# SOMERSET MASTER PLAN

Lot : HF 206  
 Address : 2222 SW Heartland Ct, LSMO

RELEASE FOR CONSTRUCTION  
 AS NOTED FOR PLAN REVIEW  
 DEVELOPMENT SERVICES  
 LEE'S SUMMIT, MISSOURI  
 10/14/2024

1 Main Level Floor Plan  
1/4" = 1'-0"

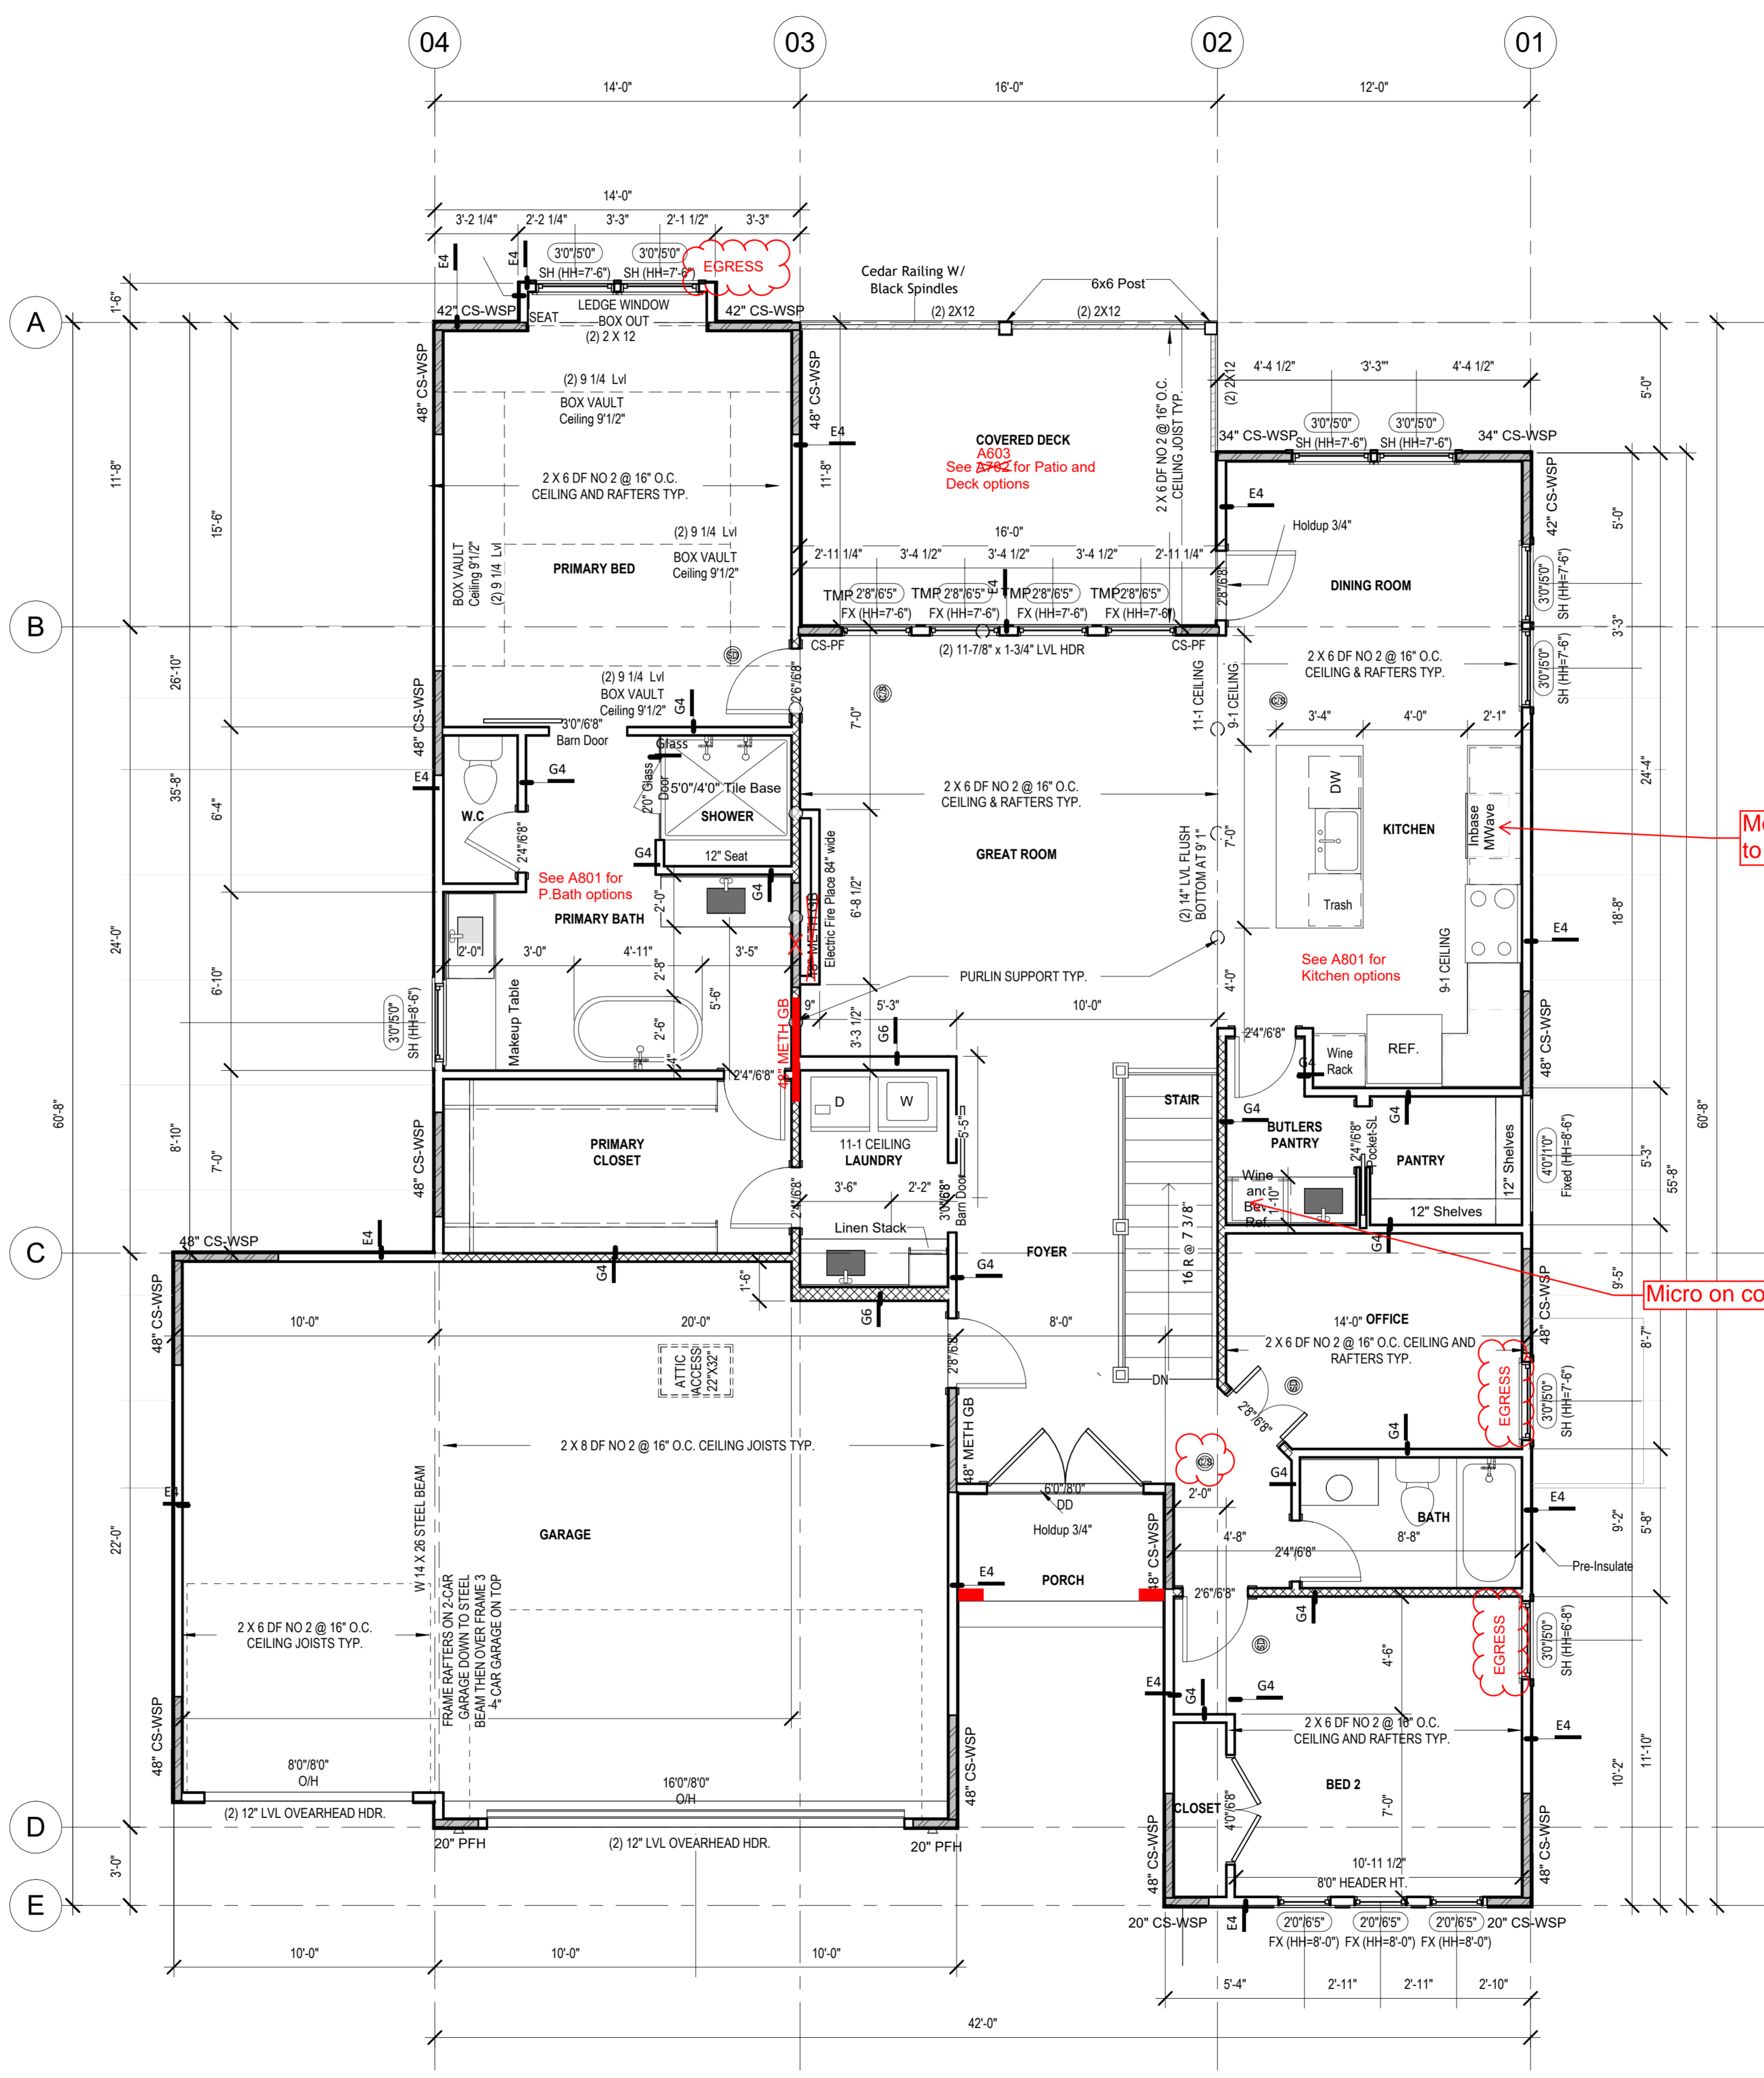
Move Micro to Pantry

Micro on counter
